COUNCIL ASSESSMENT REPORT

Panel Reference	PPSSCC-150
DA Number	DA 488/2021/JP
LGA	The Hills Shire Council
Proposed Development	Demolition of Existing Structures and Construction of Three Mixed Use and Four Residential Flat Buildings of varying heights between 8 - 13 Storeys. The development comprises of 772 Units, Lower Ground Level Neighbourhood Shops and Three Level Basement Car parking (1008 Car Spaces).
Street Address	30-36 Carrington Road, 33-39 & 36-44 Ashford Ave and 7-13 Partridge Ave, Castle Hill
Applicant	Showground Corporation Pty Ltd
Consultant/s	Town Planners: APP Surveyors: Benchmark Surveyors and Geosurv Subdivision/Staging Plan: Project Surveyors Architects: Tony Owen Partners Quantity Surveyors: RICQS Traffic Engineers: TTPP Civil, Stormwater Engineers and Sustainability: Stantec Water Course Assessment: Martens Acoustic Engineers: Acoustic Logic Ecologist: Cumberland Ecology Landscape Architect: Site Image Geotechnical Engineer: Environmental Investigation Waste Management: Elephants Foot BCA and Access: BCA Logic Legal Planning Opinion: Malcolm Craig QC Arborist: Birds Tree Consultancy

• Part C Section 6 – Flood Controlled Land • Part D Section 19 – Showground

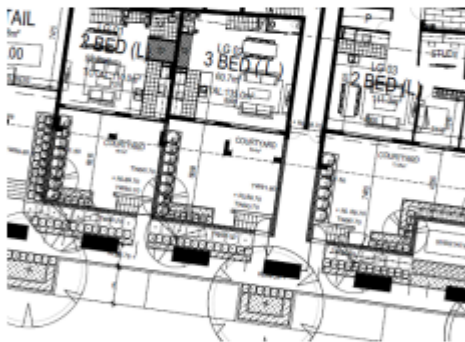
The Panel is concerned by the non-compliance with the required setbacks due to the built form bulk and scale impacts on the special character vision for the adjacent public domain of the riparian creek corridor. These non-compliances contribute to the excessive bulk and scale due to the large building footprints. For Buildings A, B and C, the Panel has recommended further consideration of upper level

setbacks, as this would help to mitigate the bulk and scale of the development blocks when viewed from within Ashford Avenue and Caddies Creek Reserve.

As previously noted, this is a highly constrained site with generous potential yield uplift. The Panel has also previously commented that poor design outcomes can result from any assumption that maximum GFA is always able to be achieved (DRP 23/06/21).

The setbacks proposed to Ashford Avenue remain inconsistent with the objectives and controls of DCP Part D19. The Applicant has had ample opportunity to amend these setbacks. In previous reports the Panel highlighted concerns with street setback proposals and public domain impacts (refer Panel Reports 30/08/19 and 08/12/20).

A. Habitable environments and dwelling spaces

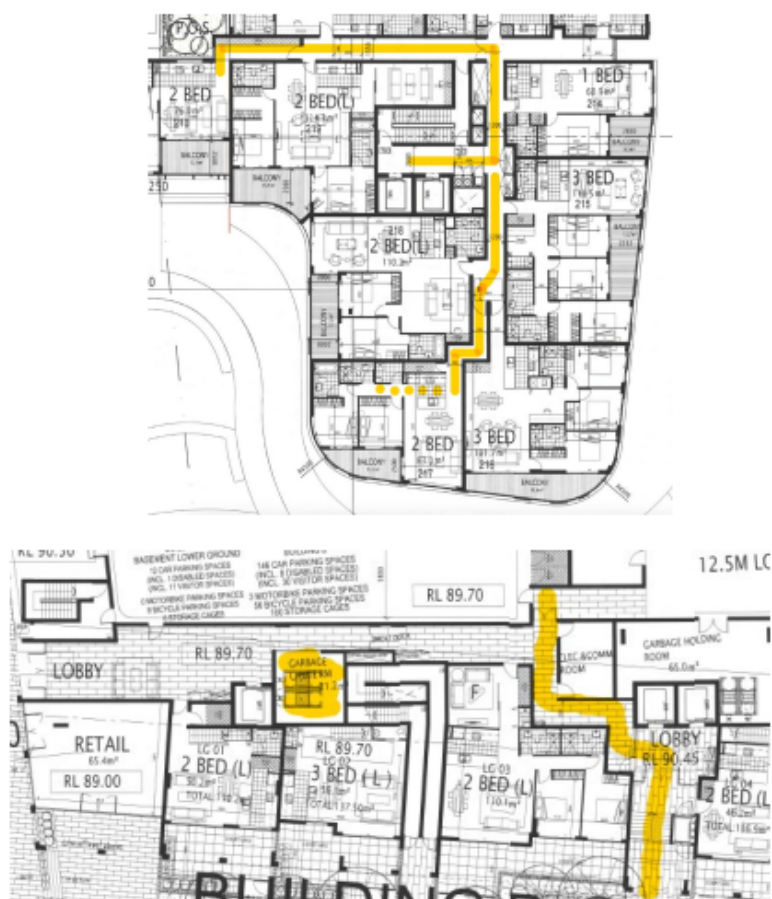
The Panel reiterates that the function of developing residential flat buildings is to provide habitable, well-planned dwellings that people would like to live in. It is therefore in the interests of the developer to provide dwellings that are desirable, particularly within an urban renewal precinct in which up to 10,000 units will ultimately be delivered that will be in direct competition with this development as it comes to market.
